**Noise Symptom - Creaking Noise from Body Front Area of the Vehicle: Replacing Upper Trailing Arm (SY 32/17)**

Model Line: **Panamera (971)**

Model Year: **As of 2017 up to 2023**

Concerns: **Rubber mounting for upper trailing arm**

*Installation position of upper trailing arm*

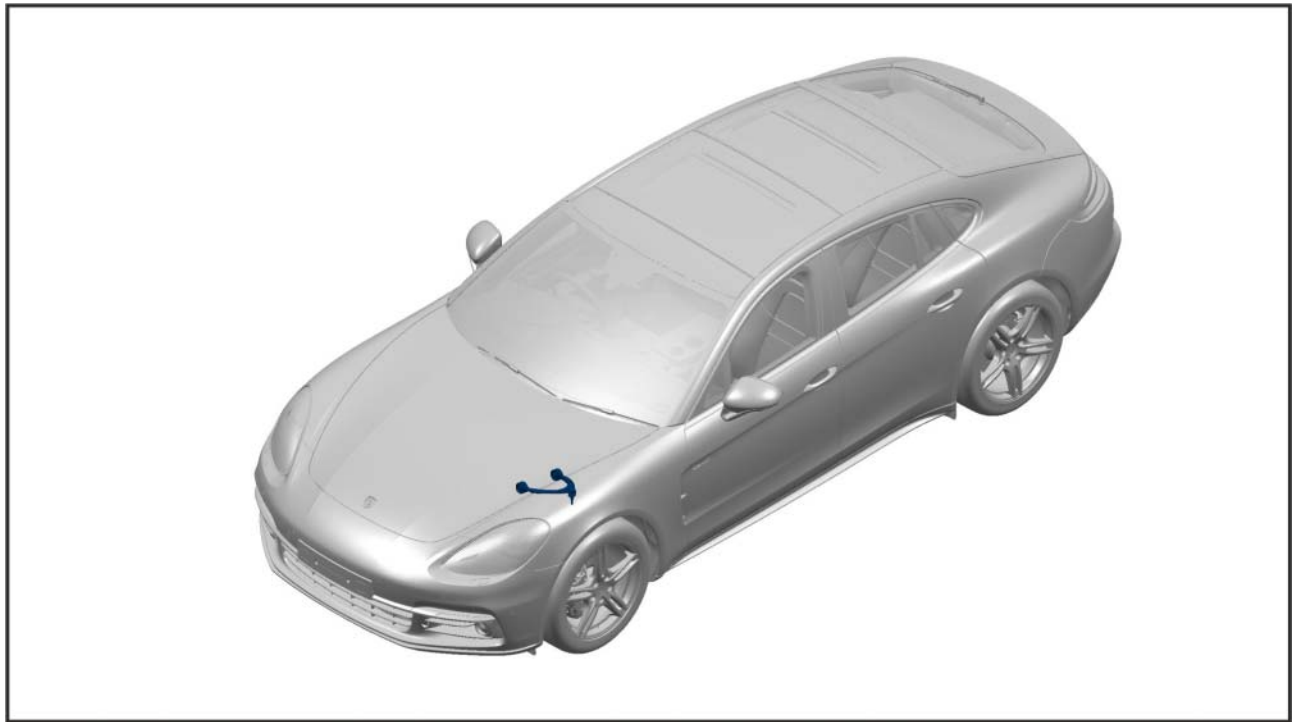
Cause: Under certain conditions, the attachment of the upper trailing arm rubber bearings to the body side can cause creaking noises.  
Temperatures below -5 °C can increase these noises.

Remedial Action: A new component status is available for the upper left and right trailing arms on the front axle.  
In the event of a comprehensible customer complaint, replace the upper left and right trailing arms on the front axle.
